MIAMI-DADE COUNTY
PUBLIC WORKS AND WASTE MANAGEMENT DEPARTMENT (PWWW)

ADDENDUM NO. 3
October 31, 2013

PROJECT: Push-Button Contract for Street Lighting Improvements
Project No. 20130212 (MCC 7040 Plan)

REVISED SHEET No.3 FOR ADDENDUM No.3

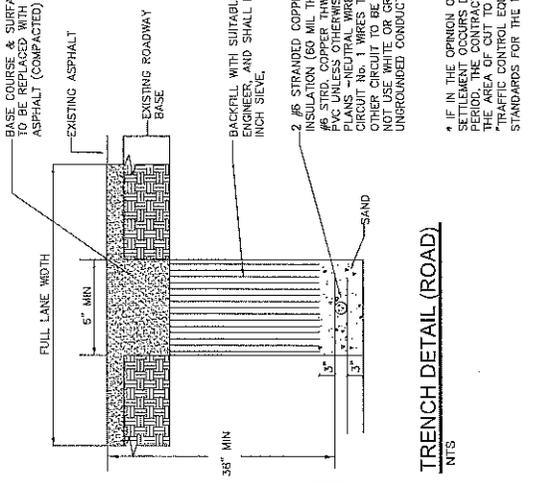
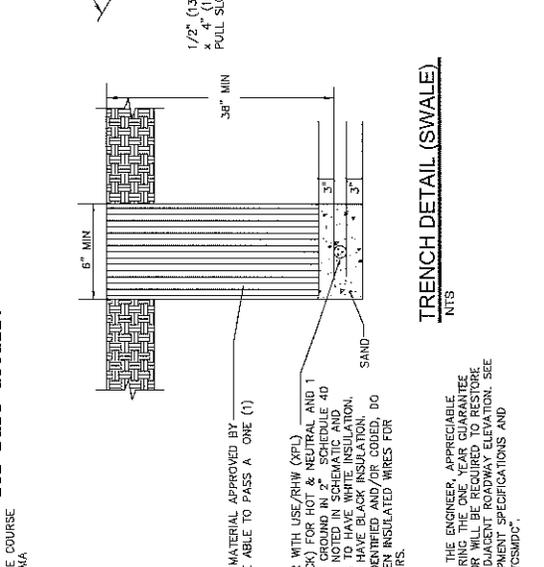
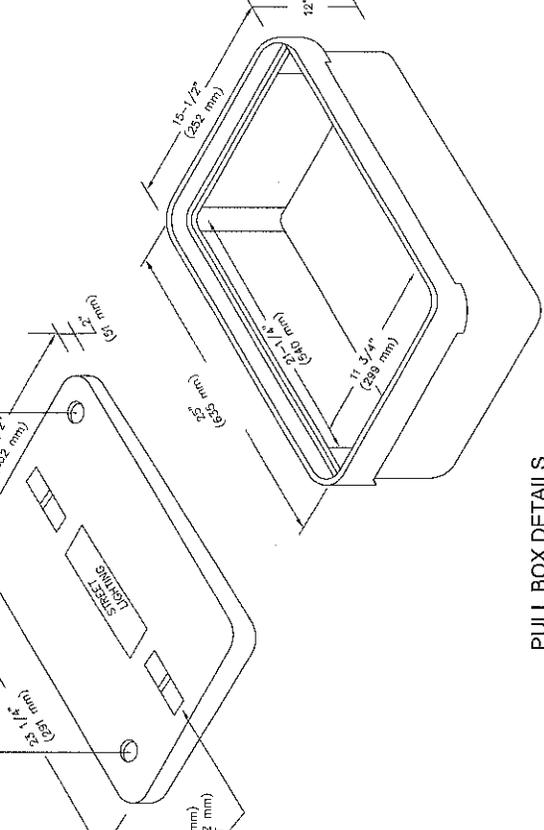
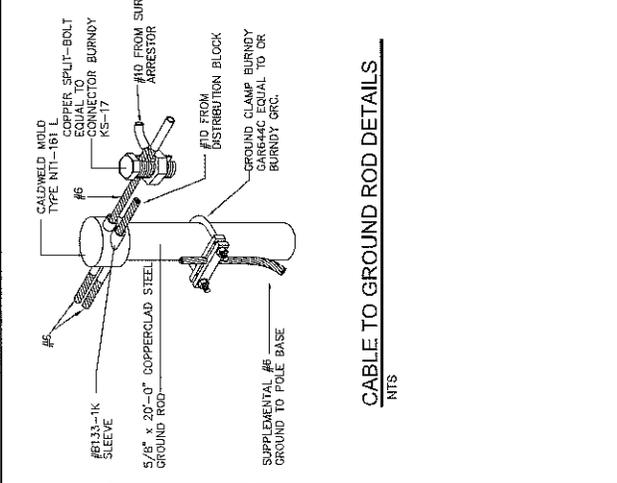
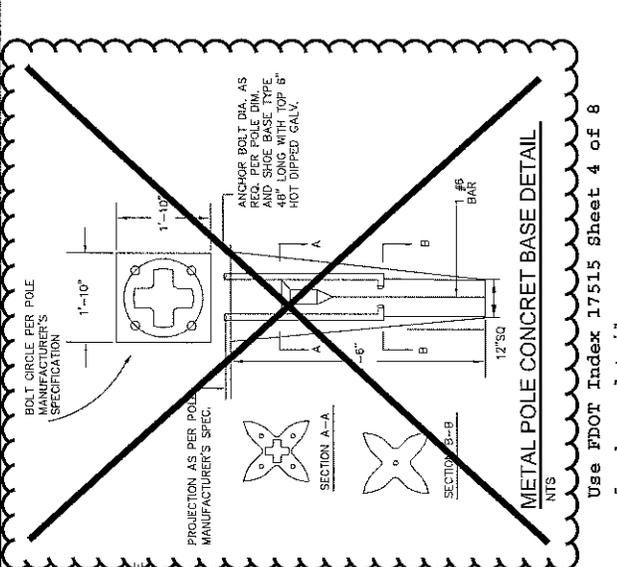
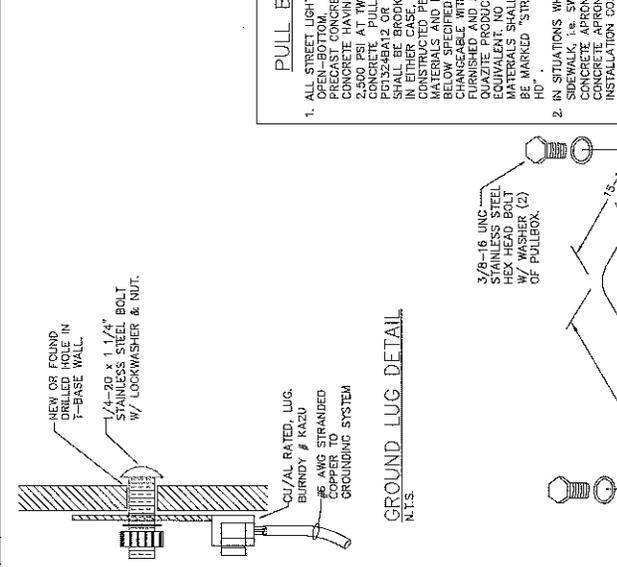
- 1) Delete Article 2.03 Highway Lighting (Section 715) and replace it with Article 715-Roadway Lighting System (Rev. 5-29-2013), attached.
- 2) Add Article 2.03, Pull and Junction Boxes (Rev. 06-23-11), attached.
- 3) Appendix B to the Special Provisions, Lighting Details.
 - a. Delete "Sheet No. 3, Pull Box and Grounding Miscellaneous Details" and replace it with Revised Sheet No. 3 for Addendum No. 3, attached.
 - b. Add Lighting Details, Sheet No. 4. Street Lighting Details Concrete Spread Footer with attached.

- ALL STREET LIGHT PULLBOXES SHALL HAVE AN OPEN-BOTTOM QUAZITE POLYMER CONCRETE DESIGN OR PRECAST CONCRETE CONSTRUCTED OF CLASS 1 CONCRETE HAVING A MINIMUM COMPRESSIVE STRENGTH OF 2,500 PSI AT TWENTY-EIGHT (28) DAYS. POLYMER CONCRETE SHALL BE EIGHT (8) DAYS POLYMER CONCRETE OR APPROVED EQUIVALENT. CONCRETE PULLBOX SHALL BE BROOKS 38 SERIES OR APPROVED EQUIVALENT. IN EITHER CASE, BOTH PULLBOXES SHALL BE CONSTRUCTED PER ABOVE SPECIFIED MANUFACTURERS SIZE AND FINISH. PULLBOXES SHALL BE FULLY INTERCHANGEABLE WITH EITHER PULLBOX. ALL PULLBOX COVERS AND INSTALLED SHALL BE POLYMER CONCRETE FINISHED WITH EITHER POLYMER CONCRETE OR APPROVED EQUIVALENT. CONCRETE PULLBOX COVERS SHALL BE FULLY INTERCHANGEABLE WITH EITHER PULLBOX. ALL PULLBOX COVERS SHALL BE MARKED "STREET LIGHTING" OR "ELECTRIC / MIAMI-DADE HD".

- IN SITUATIONS WHERE PULLBOX IS LOCATED OUTSIDE OF SIDEWALK, I.e. SWALE AREA, THE PULLBOX IS TO HAVE A 5" CONCRETE APRON (6" THICK) PLACED AROUND IT. COST OF CONCRETE APRON IS TO BE INCLUDED IN THE PULLBOX INSTALLATION COST.
